# TOLEDO-LUCAS COUNTY PLAN COMMISSIONS

REF: SUP-10006-18

SUBJECT:     Request for a Special Use Permit for Used Auto Sales at 1108 Holland-Sylvania Road.

# REVISED SITE PLAN

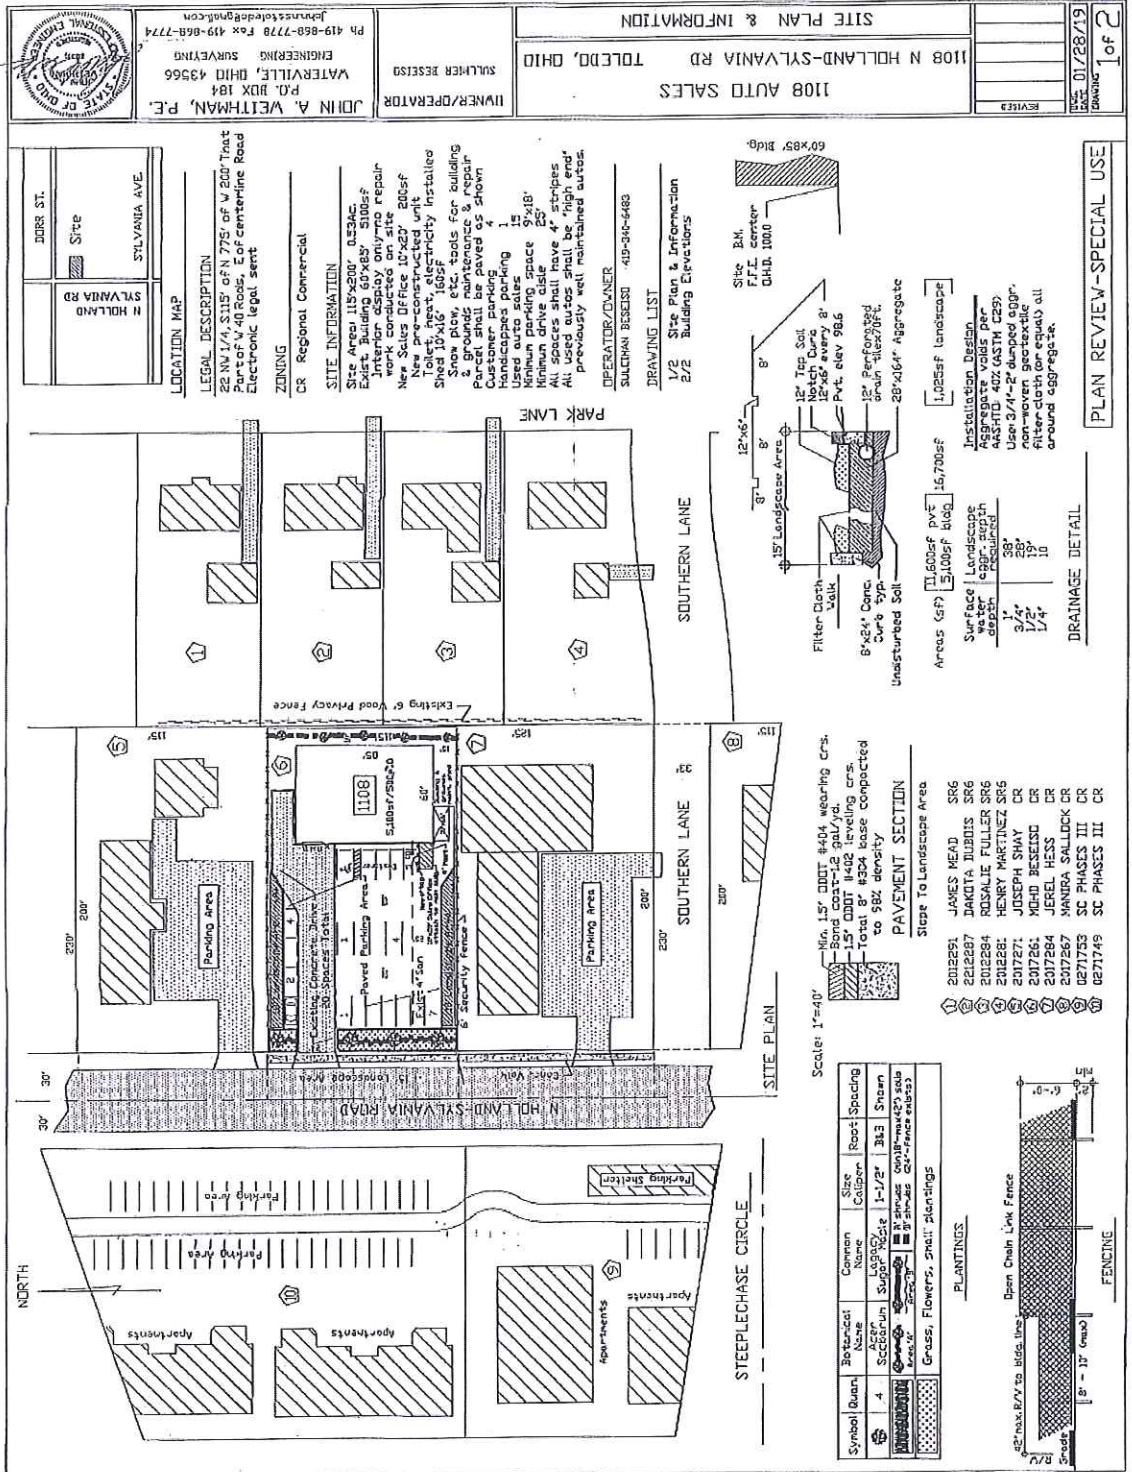
Comments from the Division of Transportation have identified several issues with the submitted site plan. First, car and van accessible parking spaces including a van accessible 8' loading area and a 5' loading area for cars must be shown based on number of spaces per TMC 1107. Second, accessible parking signs are required at each accessible parking spot per TMC 1107. If approved, a revised site plan shall be submitted addressing the Division of Transportation comments listed as conditions.

A Type A landscape buffer shall be required along the entire eastern property line of the site that abuts the residential zoning district. Said screen and buffer shall consist of a solid six-foot (6') to eight-foot (8') tall privacy fence with ten-feet (10') of landscaping with four (4) canopy trees and fifteen (15) shrubs for every 100 linear feet. A total of five (5) trees and seventeen (17) shrubs shall be installed in the Type A landscape buffer. The revised site plan submitted depicts the Type A landscape buffer along the eastern property line and complies with the applicable landscaping standards.

Additionally, per TMC§1108.0204(9)(a), a minimum ten-foot (10') perimeter landscaping buffer is required at any location where the parking lot abuts a property line. The revised site plan submitted depicts the perimeter landscaping between the parking lot and the abutting properties along the north and south property lines which complies with the applicable landscaping standards.

22. Car and van accessible parking spaces including a Van Accessible 8' loading area and 5' loading area for cars to be shown based on number of spaces per TMC 1107.
23. Accessible parking sign required at each accessible parking spot per TMC 1107.

- a. A fifteen-foot (15') greenbelt is required along Holland-Sylvania Road, and shall include one (1) tree per every thirty-feet (30') of frontage. Trees are not required to be evenly spaced and may be clustered. The frontage greenbelt shall also include a solid evergreen hedge planting to screen the parking lot so that no headlights of any vehicles can be seen from the public street. Shrubs must be a minimum height of eighteen inches (18") and maintained no greater than forty-two inches (42") along the street right-of-way. Four (4) trees with a solid hedge row is required in the frontage greenbelt; **acceptable as depicted on revised site plan received 2/1/2019.**

- b. A Type A Landscape Buffer is required along the rear of the property where the site abuts residential zoning. This buffer shall include ten-feet (10') of landscaping, include four (4) canopy trees and fifteen (15) shrubs for every 100 linear feet, and a solid wood, board on board fence; **acceptable as depicted on revised site plan received 2/1/2019.**

- h. Perimeter landscaping must be installed along any parking lot area adjacent to a street, place or driveway, or which is visible from an adjacent property, and shall be ten feet (10') in width; **acceptable as depicted on revised site plan received 2/1/2019.**

# REVISED ELEVATIONS

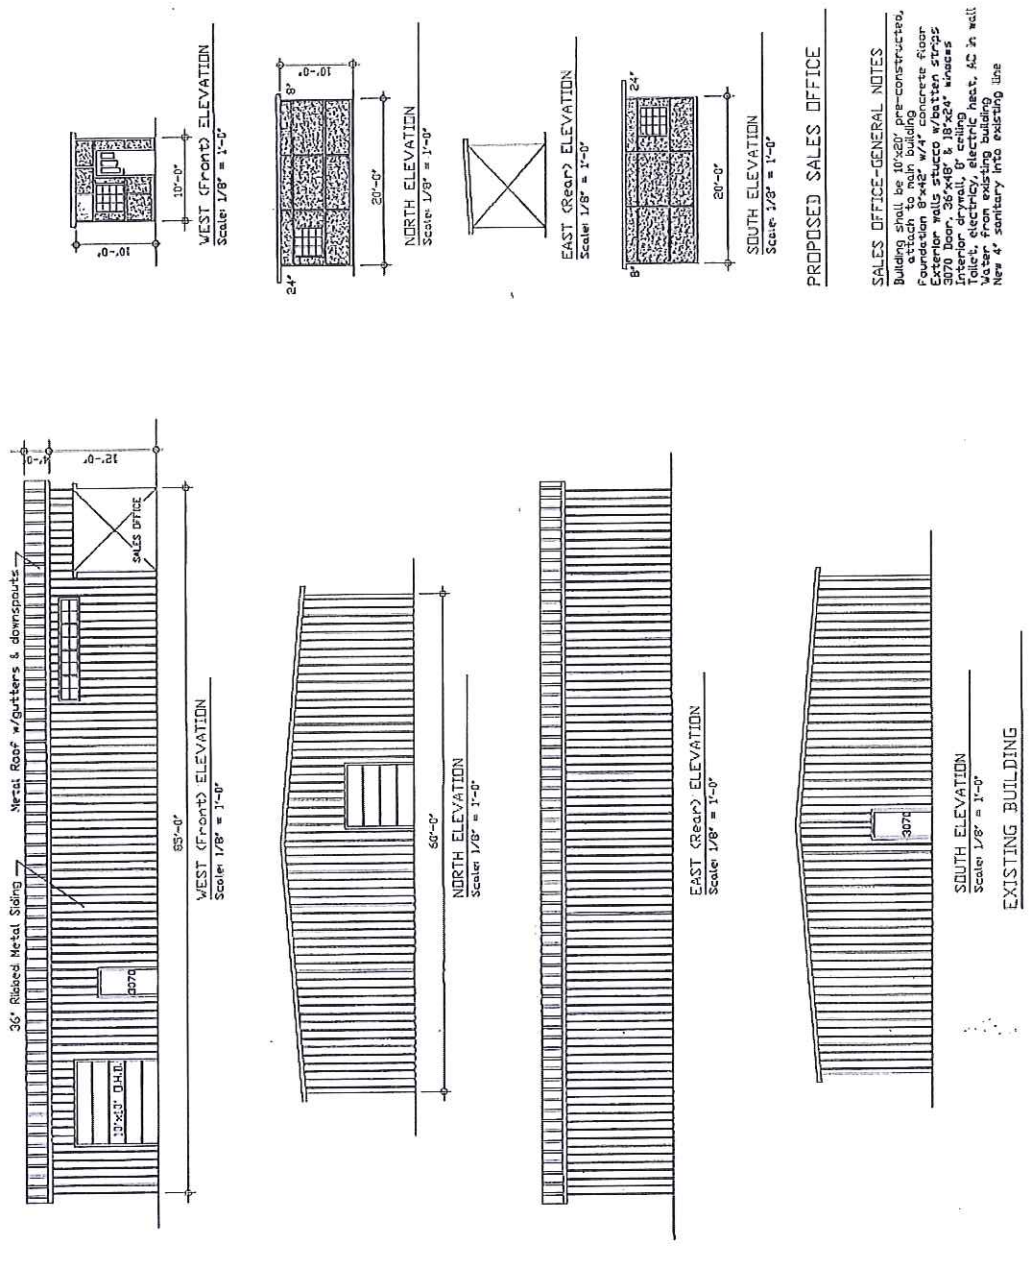
The site plan submitted depicts a building addition located on the front of the existing building. The revised building elevations submitted depict the building façade material as stucco which conforms with the Design Standards of TMC§1109.0500.

33. The building design shall meet the requirements of TMC§1109.0500 *Building Façade Materials and Color*. For facades visible from the public right-of-way, predominant materials must comprise at least seventy-five percent (75%) of the total wall area of the façade. Exterior building materials shall not include concrete blocks, concrete panels or wood sheet goods as a predominant material. **Acceptable as depicted (stucco) on revised elevations received 2/1/2019.**
